Environmental Review Team Report

Clintworth Peat Excavation

Killingworth, Connecticut

Environmental Review Team
Report
on
Clintworth Peat Excavation
Killingworth, Connecticut
August 1980

WATERSHED OF PEAT-REMOVAL SITE KILLINGWORTH

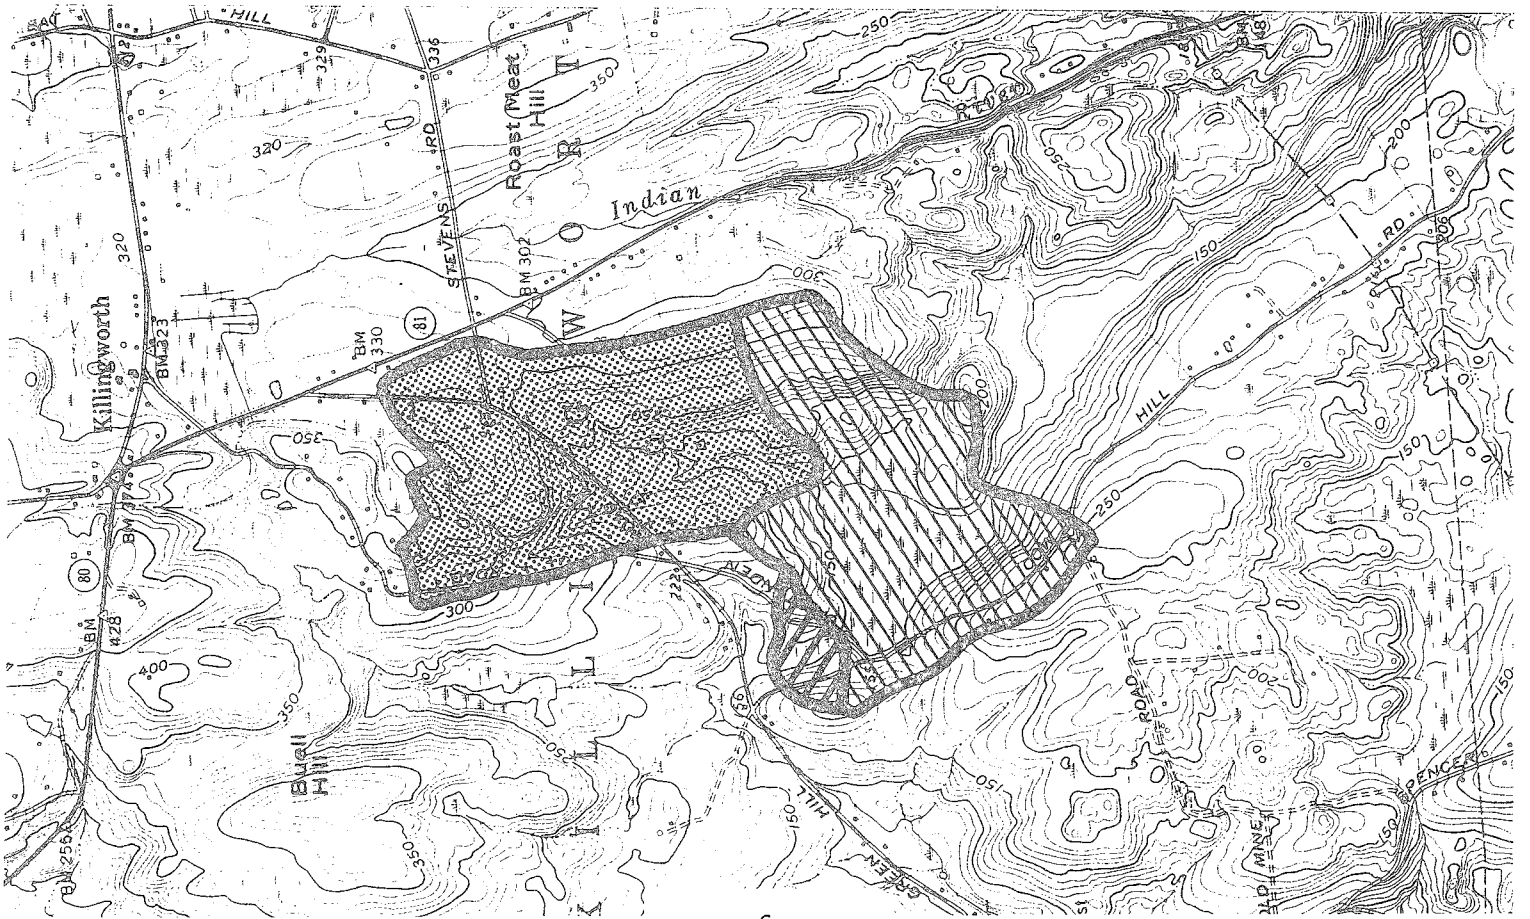
The present hydrology of the swamp may be examined in terms of inputs and outputs. Water inputs to the swamp consist of ground and surface water inflow from the upstream drainage area and precipitation over the swamp itself. The total watershed of the swamp includes approximately 360-370 acres. An area of about 15 acres which feeds a swampy swale between Chittenden Road, Cow Hill Road, and Green Hill Road may also be part of the watershed; however, the channelized connection shown on the topographic map between the swale and the major swamp was not discernible in the field. If no connection exists on the surface, there still may be groundwater movement between the two areas. The overall watershed is shown in an accompanying illustration.

AREA OF MOST SERIOUS AND
FREQUENT TRAFFIC ACCIDENTS

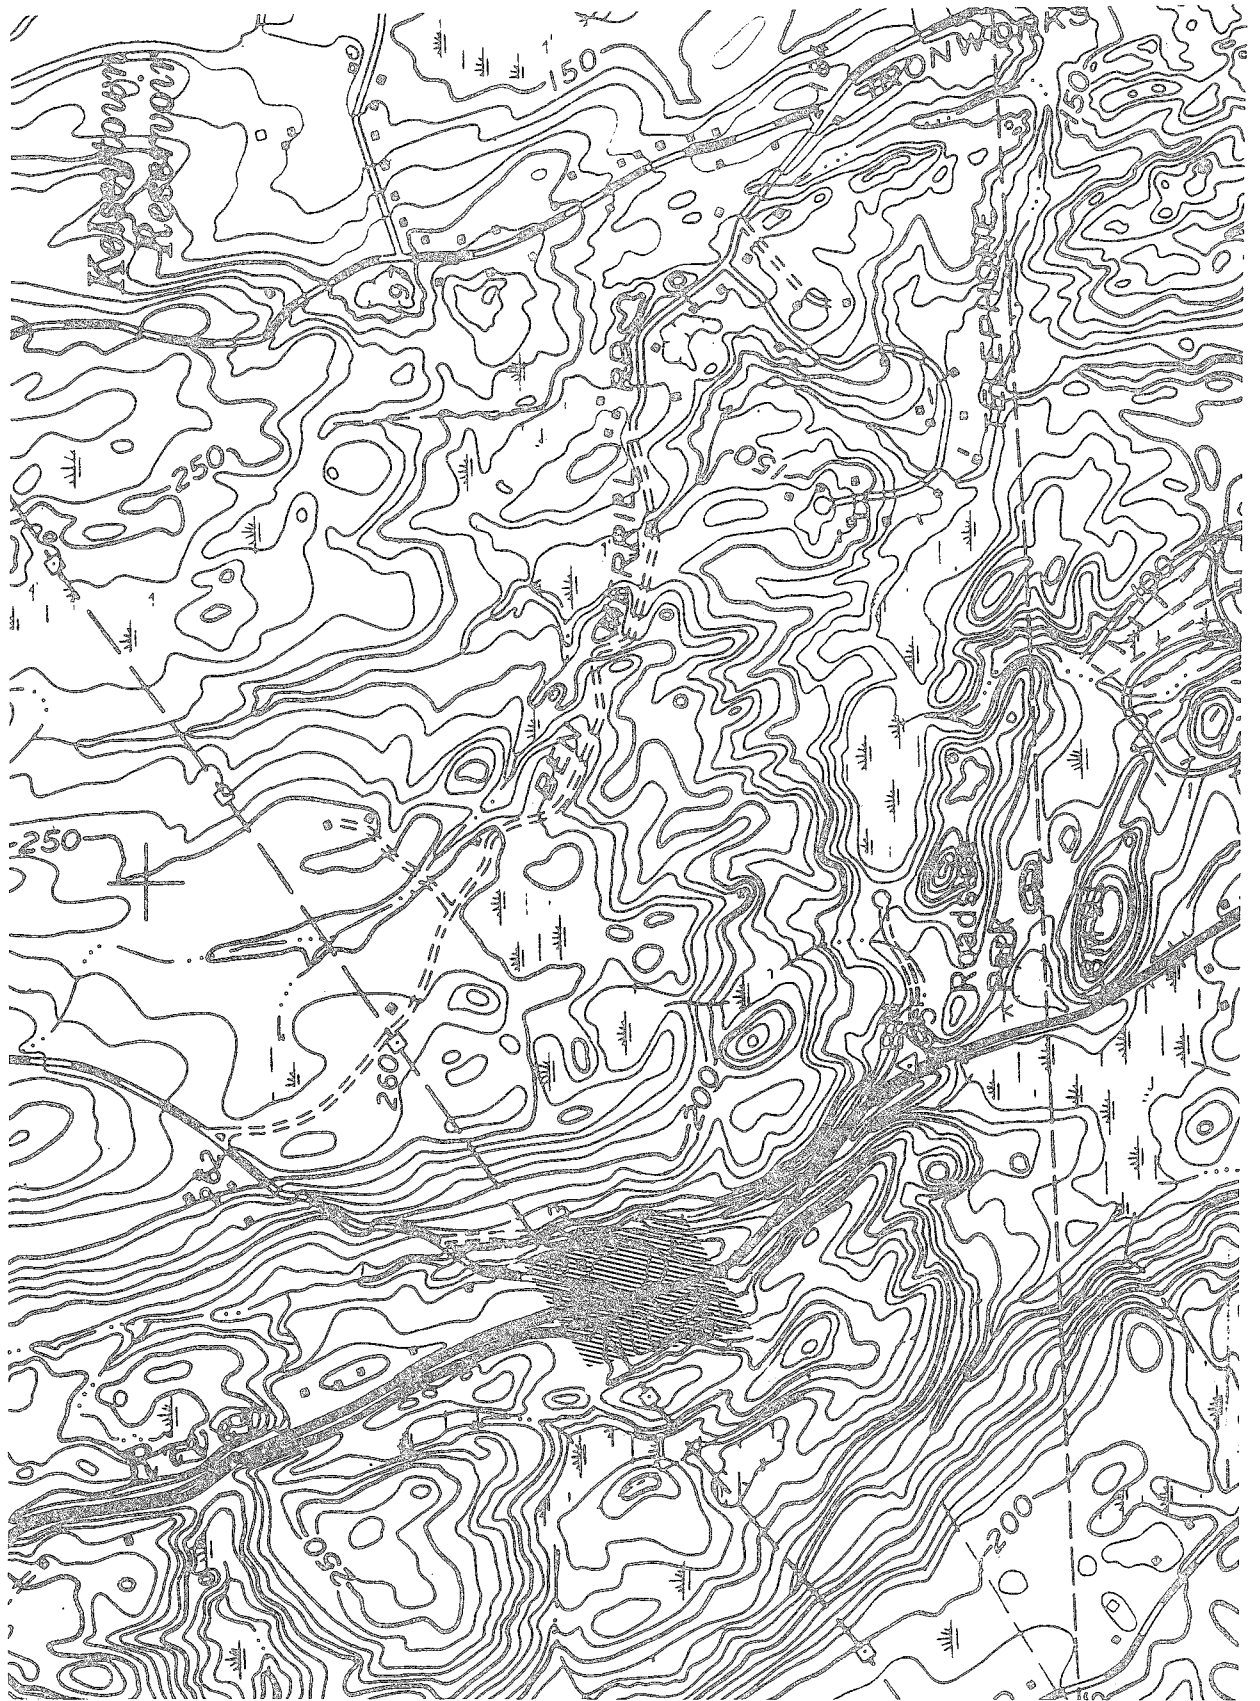
Some recently received CONNDOT Accident Experience Data that has been analyzed for Route 81 in the vicinity of the proposed haul road encroachment (mile marker 3.39 Indian River north to 3.68 Clinton/Killingworth town line) follows. (See accompanying map). Accident data is for the period 10/1/76 through 9/30/79.

- 1) Direction - South bound vehicle accidents 7
 North bound vehicle accidents 4

- 2) Injuries - as observed at scene:
4 very serious - disabling
2 less serious - not disabling
3 injuries - but no visible indication
0 fatalities
9 at or near vicinity of Roast Meat Hill Road to Indian River crossing.

- 3) Type -
Vehicles traveling straight and hitting fixed objects of adjacent bank or ledge - during the period an equal number of accidents occurred when road conditions were dry as well as wet (rain, snow, slush).

- 4) Multiple Vehicle Accidents -
July 17, 1977 - 2 cars sideswipe in opposite directions at night 5 injured
Feb. 4, 1977 - 2 cars involved skidding on snow-striking nearby 2 injured
 bank/ledge
Jan. 11, 1978 - 2 vehicles involved, 1 hitting nearby bank/ledge
 when avoiding other vehicle.

Stabilized construction entrance

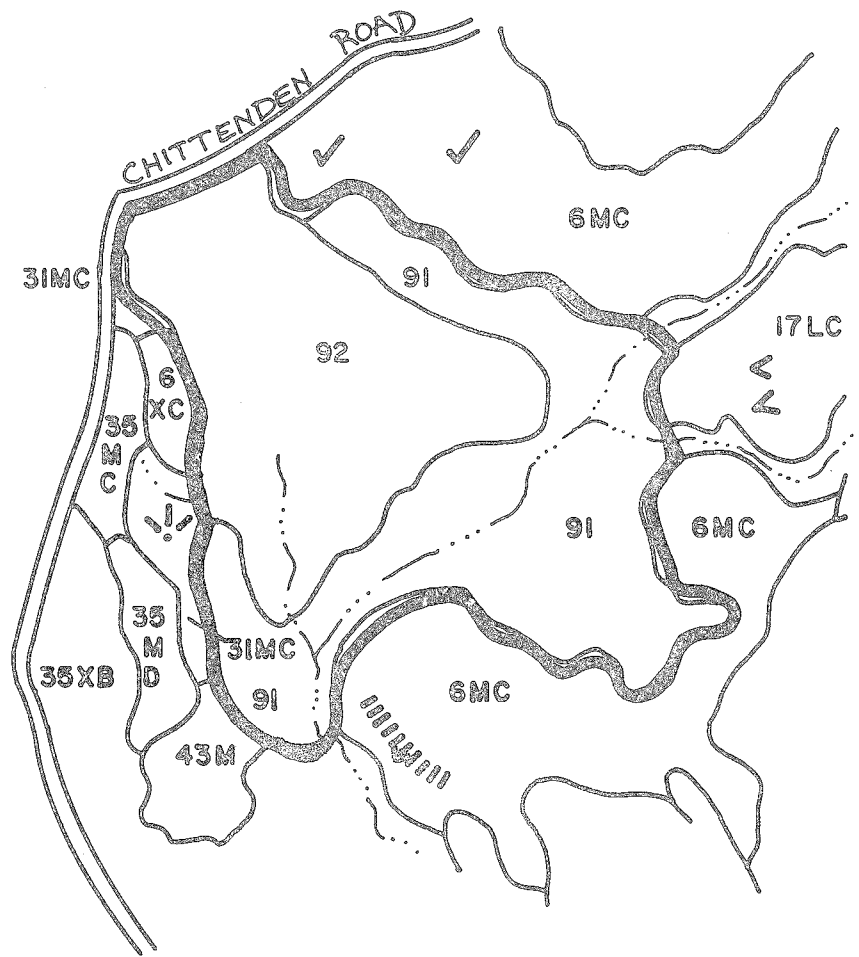
As part of the design of the haul road consideration might be given to a stabilized construction area of crushed stone to reduce or eliminate the tracking of sediment onto Route 81. (See accompanying illustration).
